Standards Committee

Meeting Agenda

TITLE	Champion
2nd time to Committee. Discussed in May. Twenty (20) proposed drawings and revisions to WVDOH Standard details Book – Volume 2. The sheets are listed below. A summary of each sheet's revisions are included in the meeting packet; and proposed sheets have revised areas highlighted yellow. a) <i>TE1-3A Roadside Sign Supports Steel Beam Type</i> b) <i>TE1-3B Roadside Sign Supports Steel Beam Type</i> c) <i>TE1-3C Roadside Sign Supports Steel Beam Type</i> d) <i>TE2-1A Bridge or Retaining Wall Sign Mounting, Type K 1 & 2 Supports</i> e) <i>TE2-1B Bridge or Retaining Wall Sign Mounting, Type K 1 & 2 Supports</i> f) <i>TE2-2 Bridge or Retaining Wall Sign Mounting, Type L Pipe Post Mount</i> g) <i>TE2-3 Barrier Wall Sign Support Bracket Type D</i> h) <i>TE3-1 Overhead Sign Support – Steel Two Tube Span (TTS)</i> i) <i>TE3-2 Overhead Sign Support – Steel One Tube Span (OTS)</i> j) <i>TE4-3A Overhead Sign Support – Steel Double Arm Cantilever</i> k) <i>TE4-3B Overhead Sign Support – Butterfly Cantilever</i> l) <i>TE4-4A Overhead Sign Support – Single Arm Cantilever (Heavy)</i> m) <i>TE4-4B Overhead Sign Support – Single Arm Cantilever (Ligh

STANDARD SHEET TE2-1A

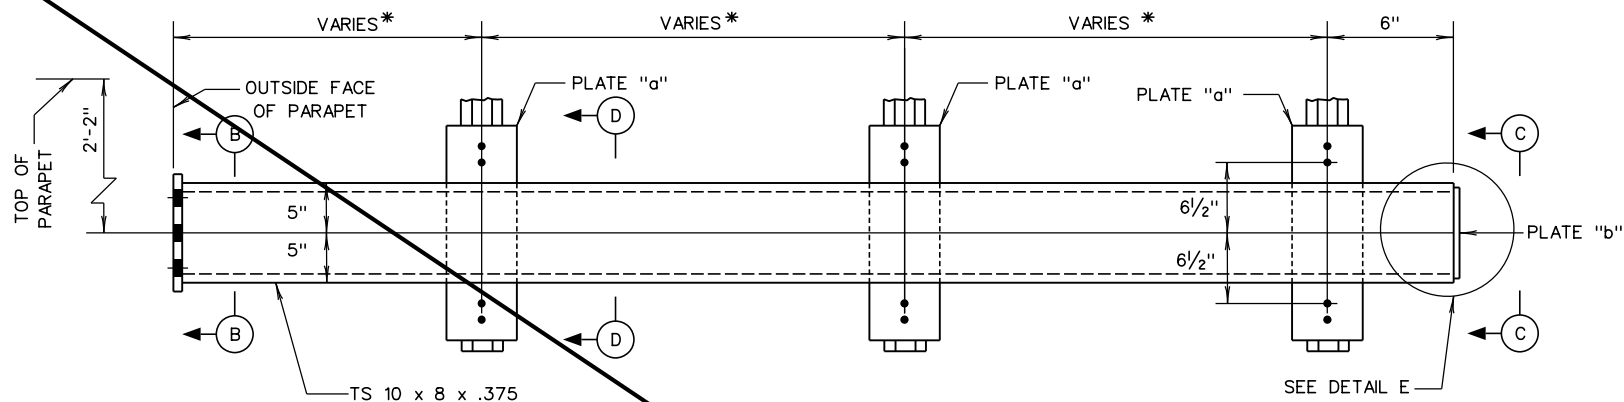
REVISED NOTE 2 TO REMOVE REFERENCE TO
3-POST SUPPORT AND LIMIT SIGN WIDTH TO 6'.
REVISED NOTE 3 TO CLARIFY LOADS.
REVISED BASE PLATE DIMENSIONS TO
INCREASE BOLT QUANTITY TO 8.

**BRIDGE OR
RETAINING WALL
SIGN MOUNTING
TYPE L
PIPE POST MOUNT
STANDARD SHEET TE2-2**

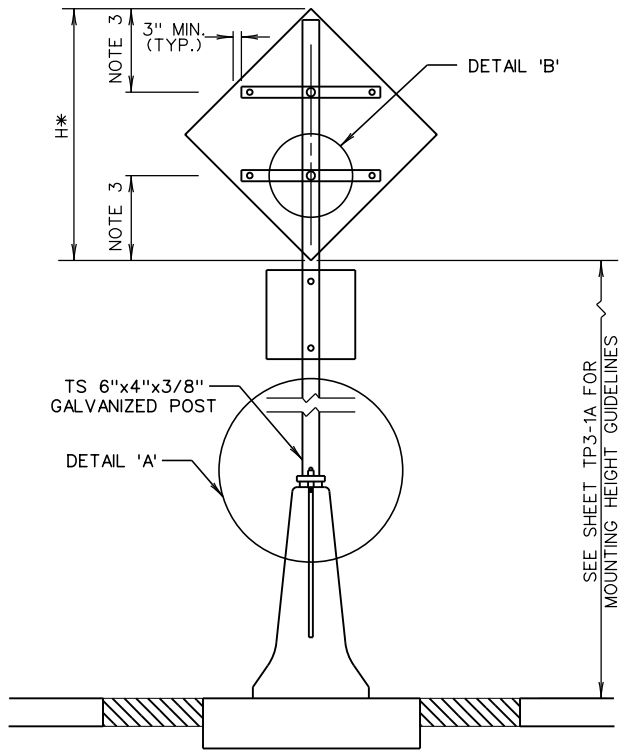
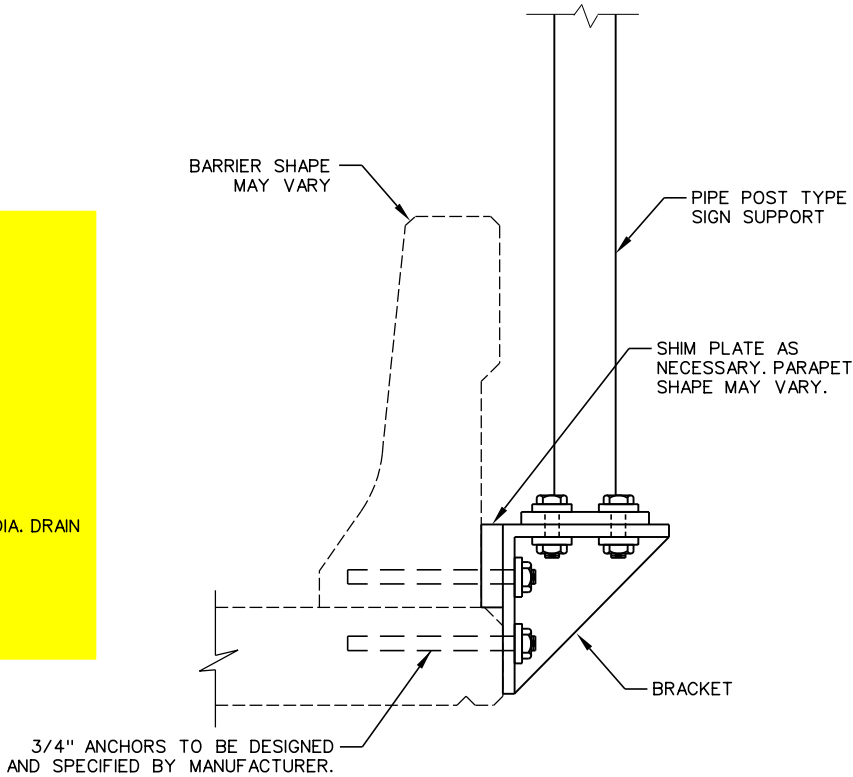
ADDED NOTE 4.
REMOVED REFERENCE TO TYPES 7 & 8.
INCREASED WIDTH OF BRACKET AND
INCREASED NO. OF ANCHORS TO 8.

STANDARD SHEET TE3-2

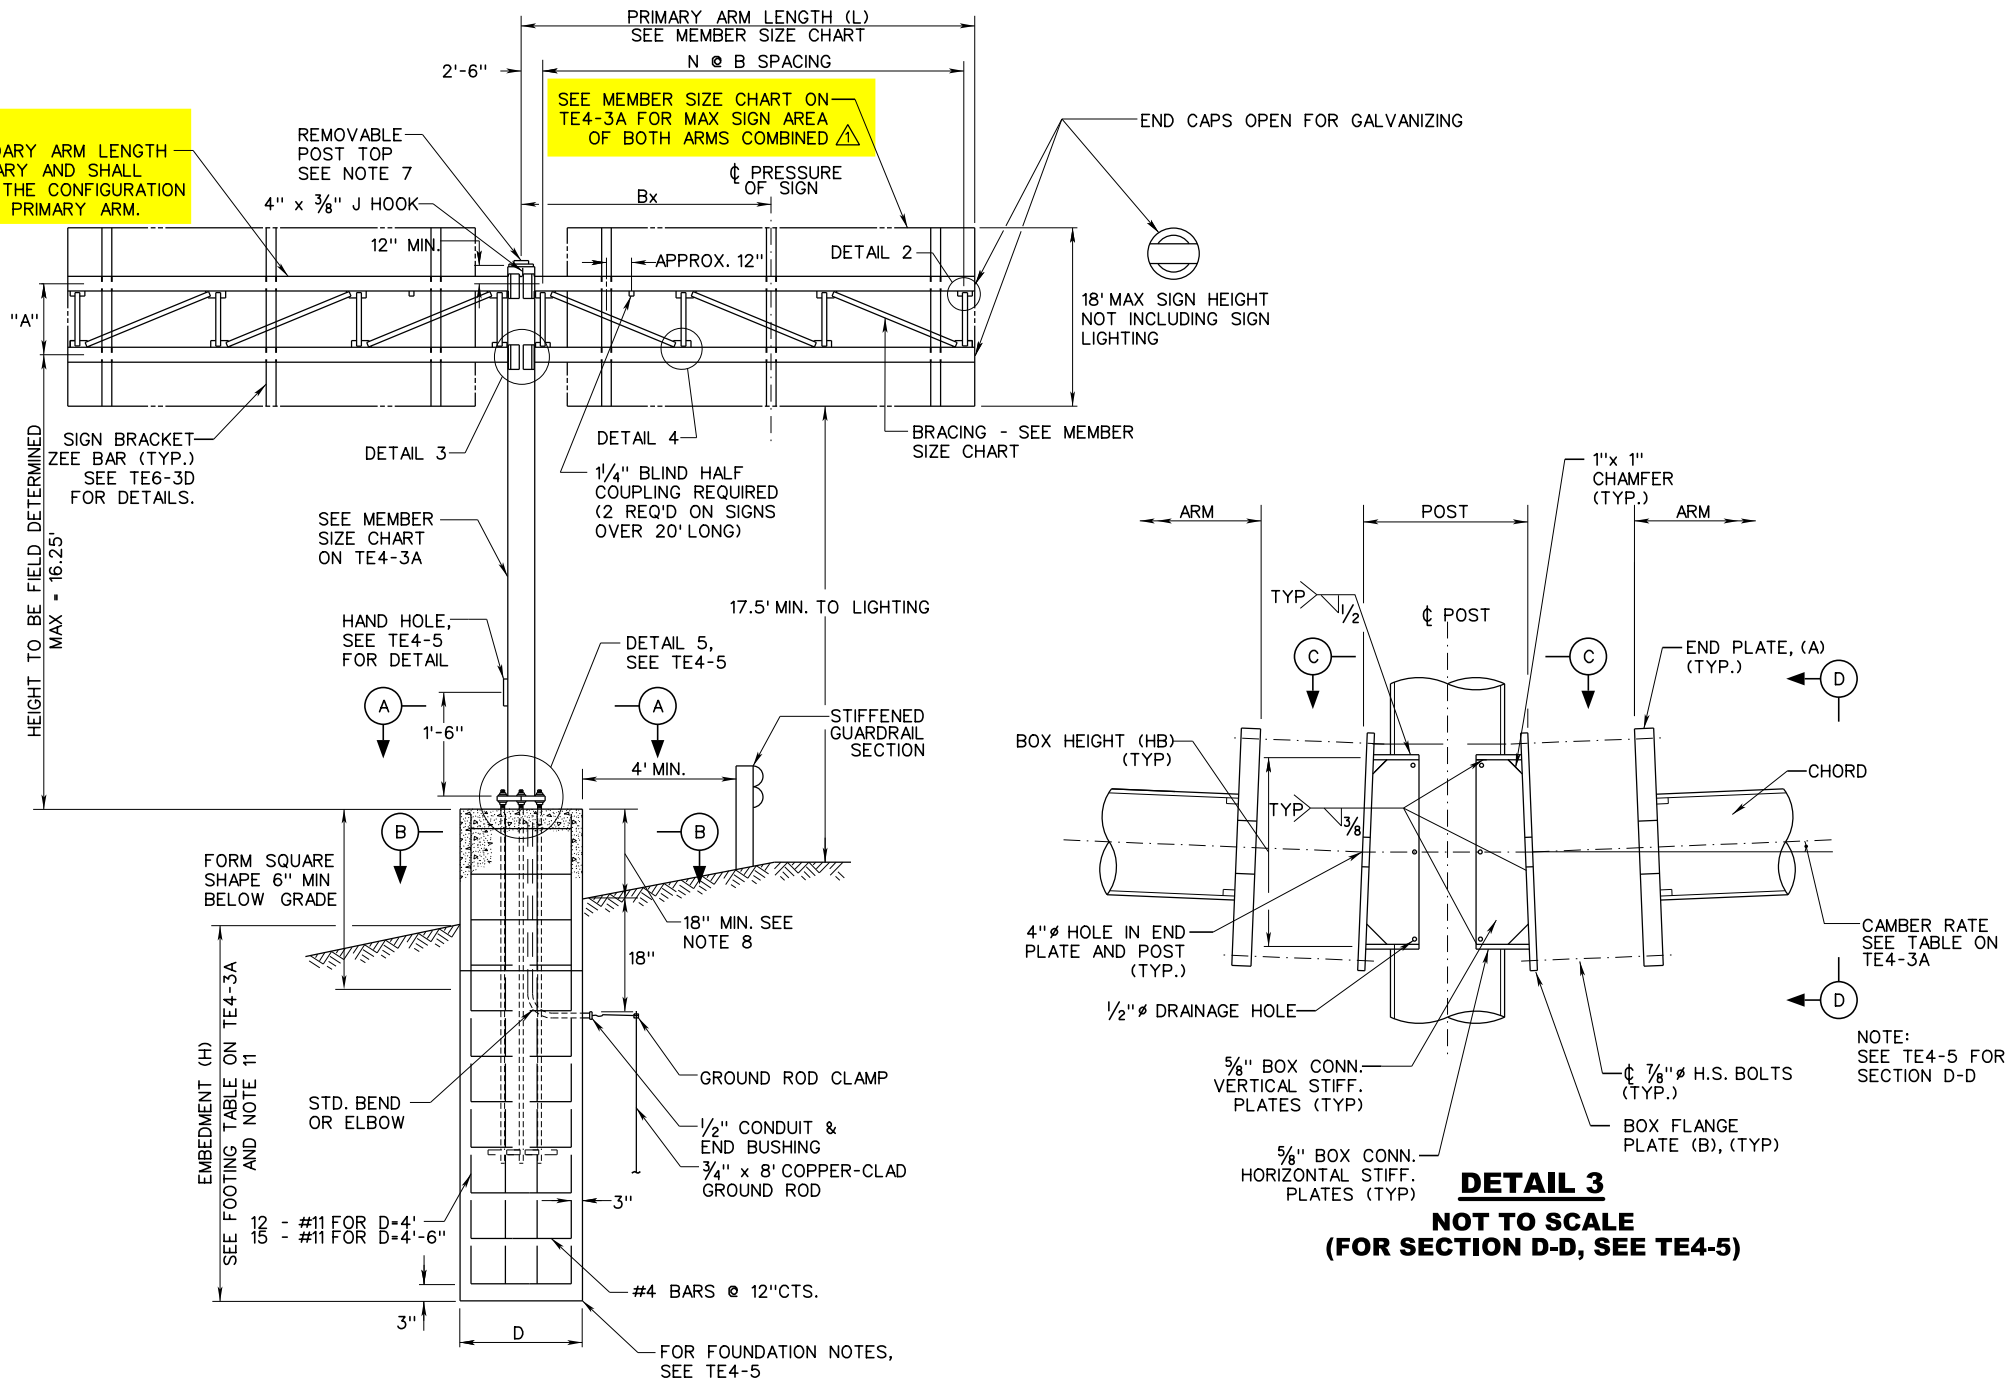
ADDED CAMBER INFORMATION
REVISED TABLE, REVISED BRACKET SIZE

STANDARD SHEET TE4-3B

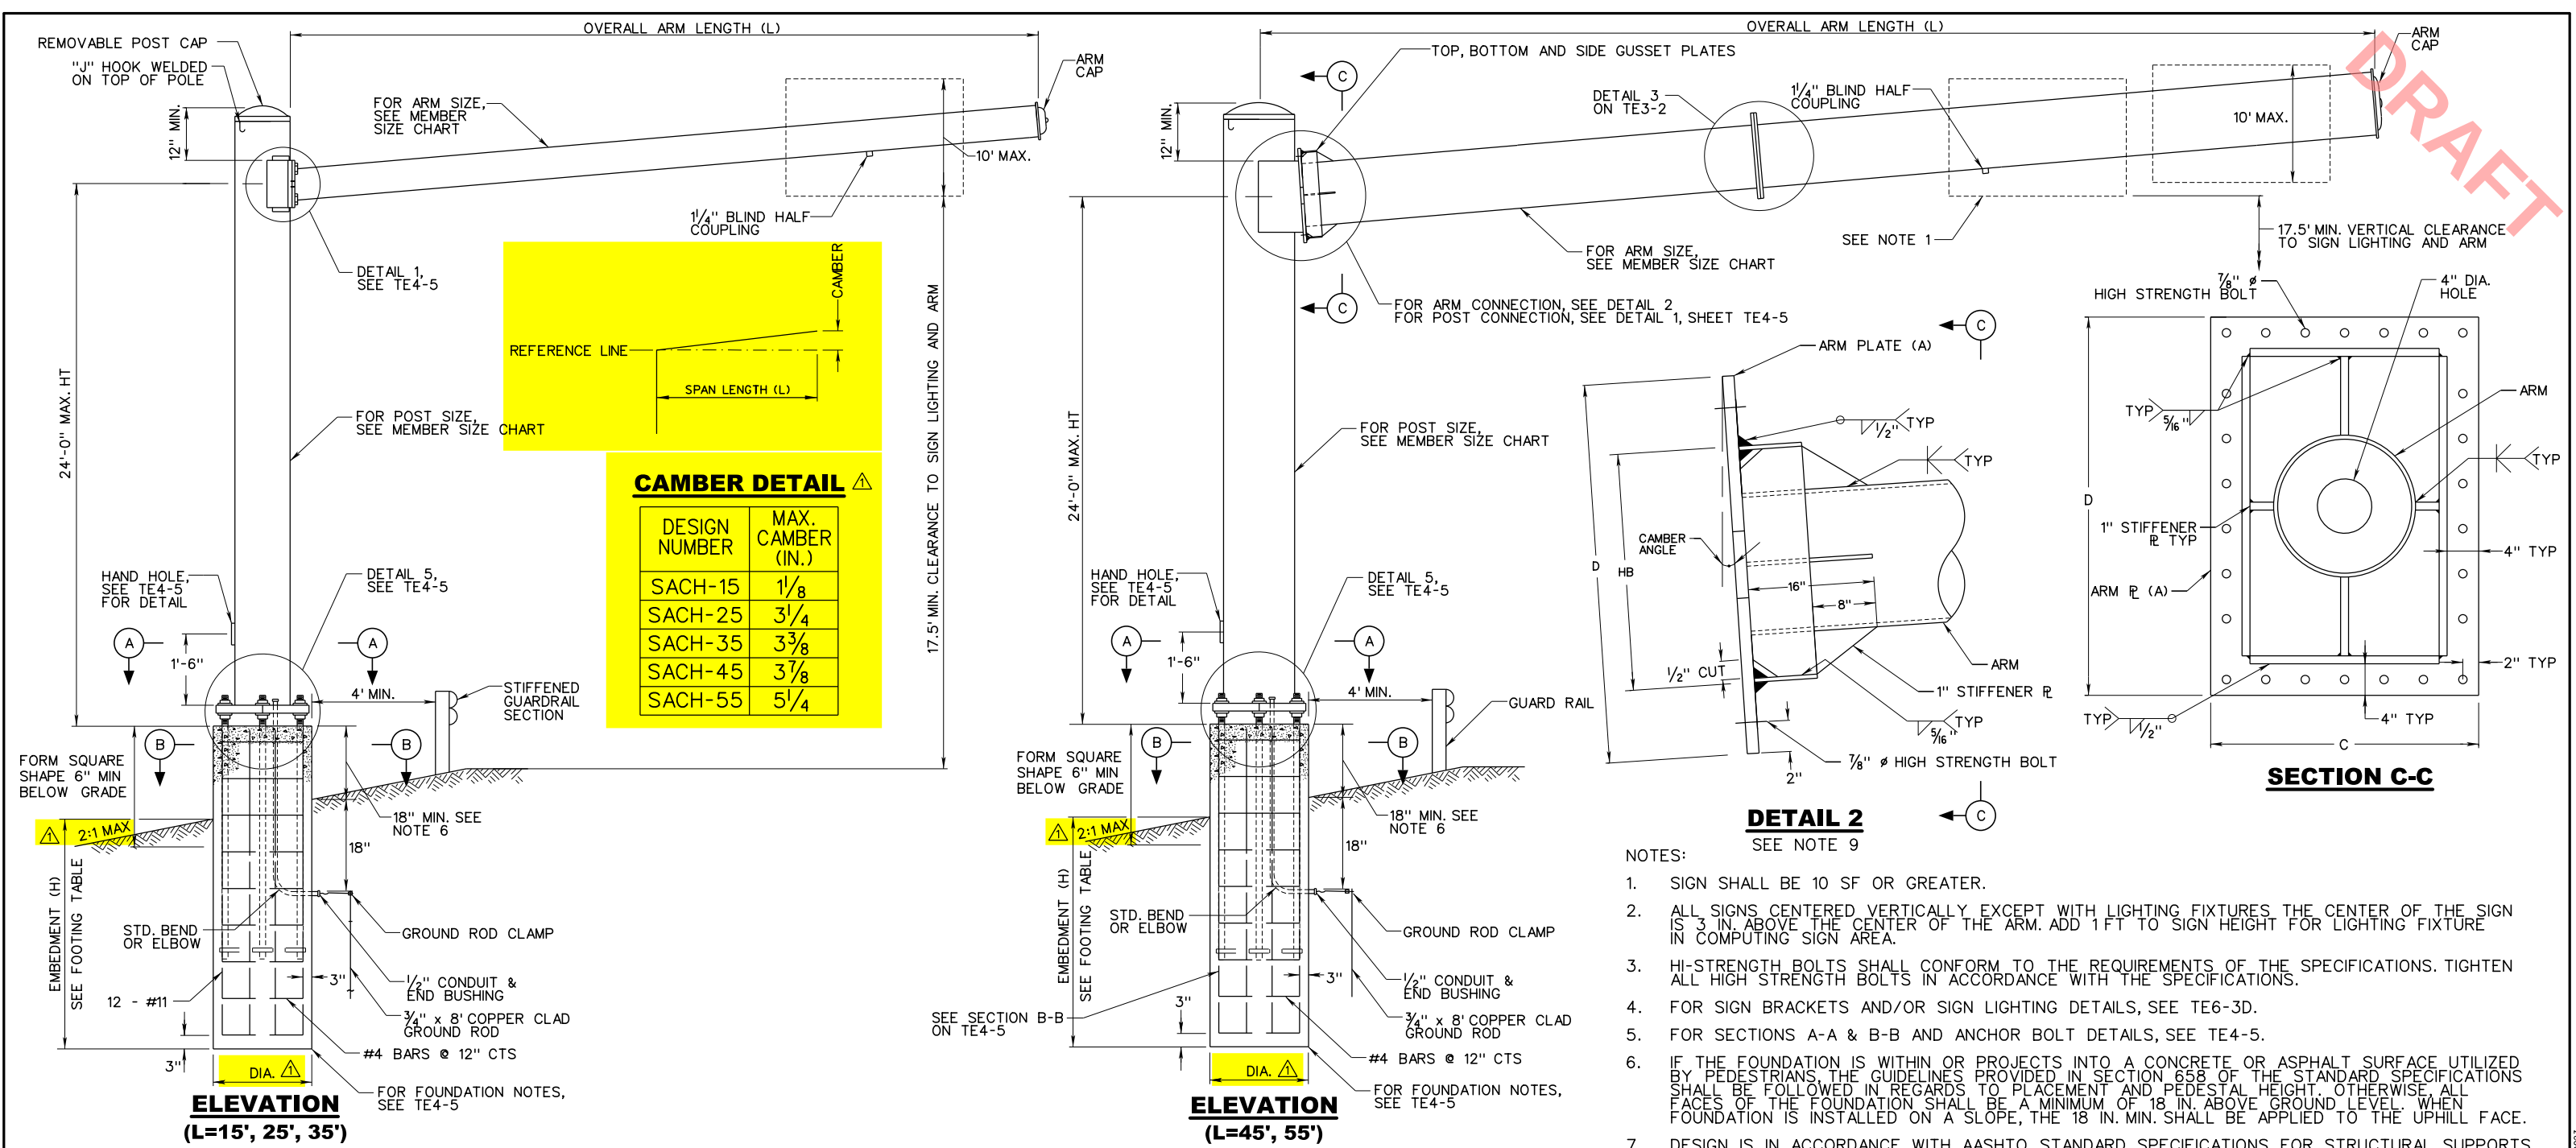
⚠️ REVISED RULES FOR ALLOWABLE SIGN AREA AND SECONDARY ARM MEMBER SIZES

STANDARD SHEET TE4-4A

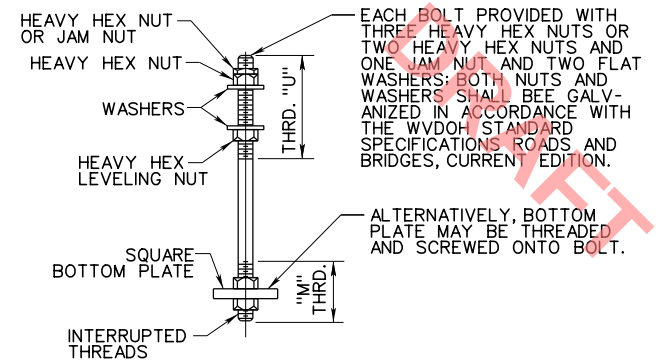
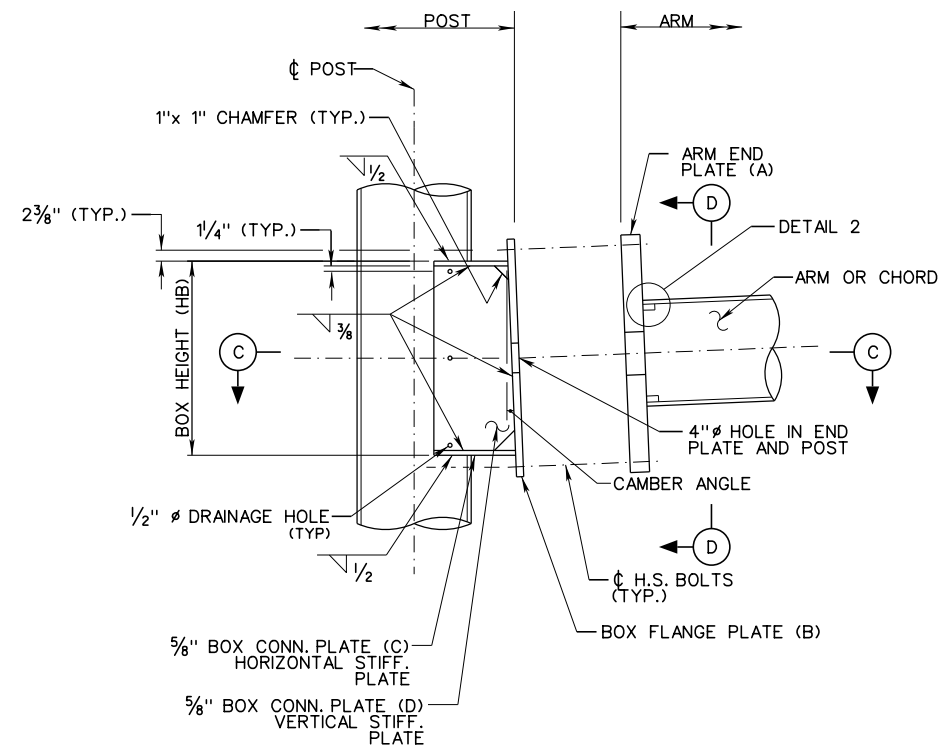
REVISOR FOUNDATION DIAMETER AND EMBEDMENT DEPTH FOR 45' & 55' ARM LENGTHS. ADDED SOIL PARAMETER NOTE AND 2:1 MAX. ALLOWABLE SLOPE TO ELEVATIONS. REVISED BOX CONNECTION TABLE TO ADD W DIMENSION. REVISED POST AND ARM SIZES FOR 45' & 55' ARM LENGTHS AND AFFECTED BASE PLATE DIMENSIONS. MOVED FOOTING DIAMETER INFORMATION TO THE CHART. ADDED BASE PLATE HOLE SIZE INFORMATION. ADDED CAMBER DETAIL AND CHART.

STANDARD SHEET TE4-5

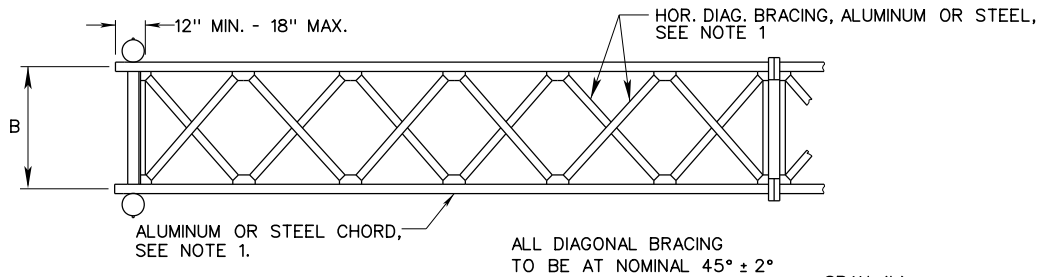
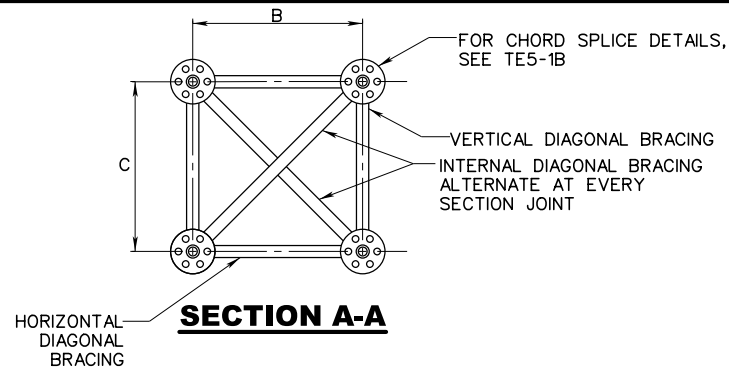
1 REVISED REINFORCING BASED ON
FOOTING SIZE CHANGES ON TE4-4A

STANDARD SHEET TE5-1A

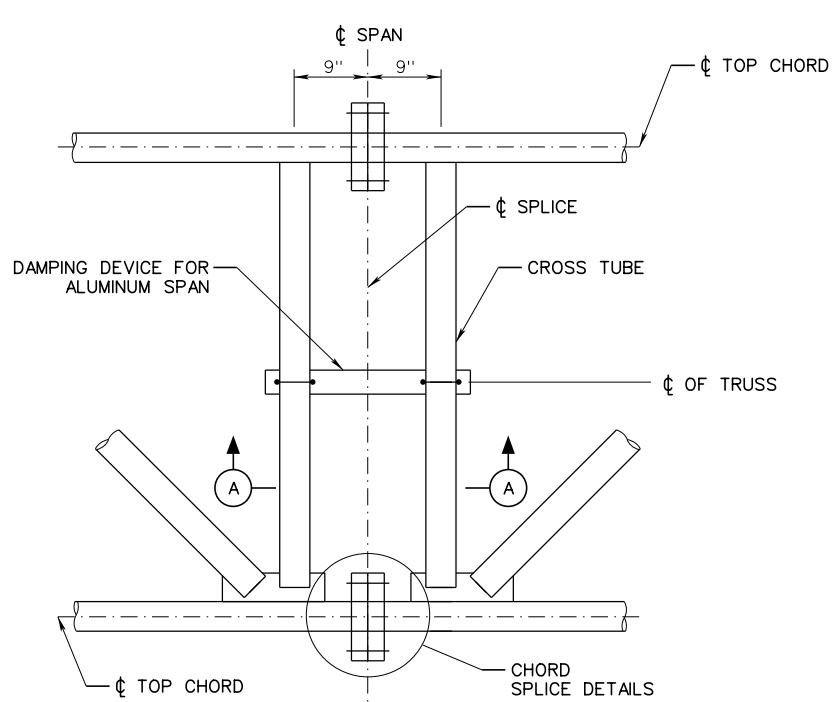
REVISD CHORD MEMBER SIZES, DELETED WELD
ADDED CAMBER INFORMATION, REVISED MAX SPAN SECTION LENGTH

STANDARD SHEET TE9-1

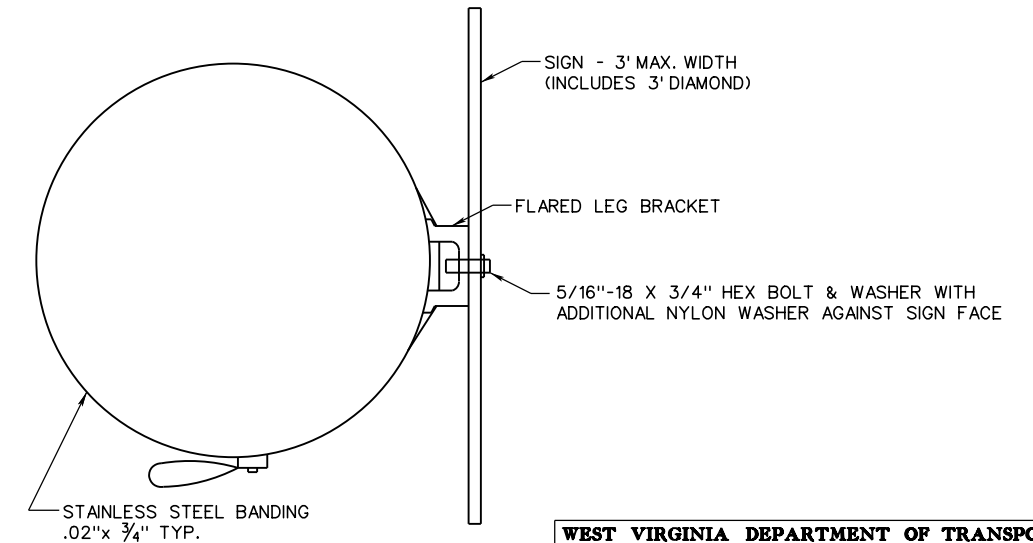
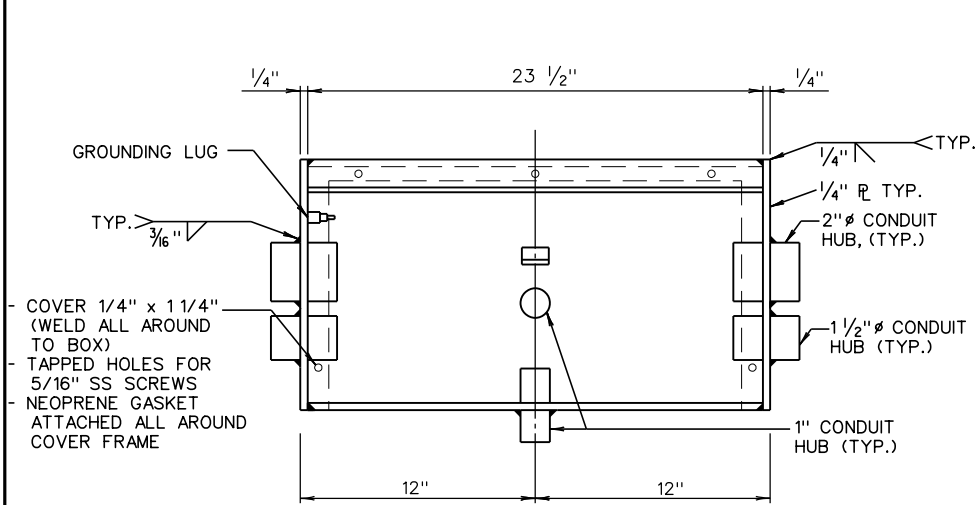
ADDED SADDLE TO U-BOLTS
